The enclosed sealed source certificates received from your Office, require some revision in order to be entered into the NRC nationwide registration system.

REGISTRY OF RADIOACTIVE SEALED SOURCES AND DEVICES
SAFETY EVALUATION OF DEVICE

NO: MA-115-FS

MODELS: NES-8470, NES-8480, NES-8490

ATTACHMENT 1

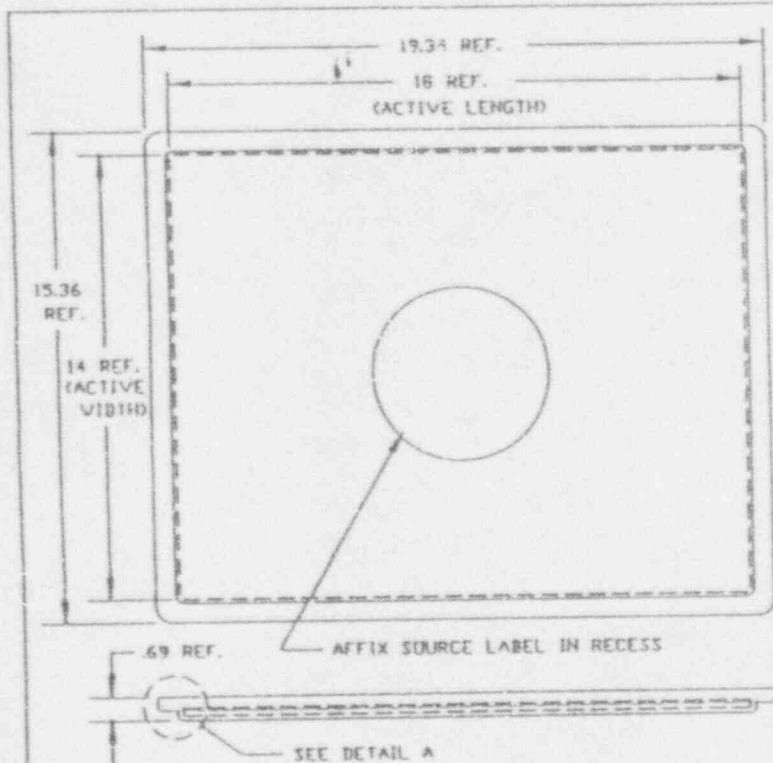
Drawings: Not attached -
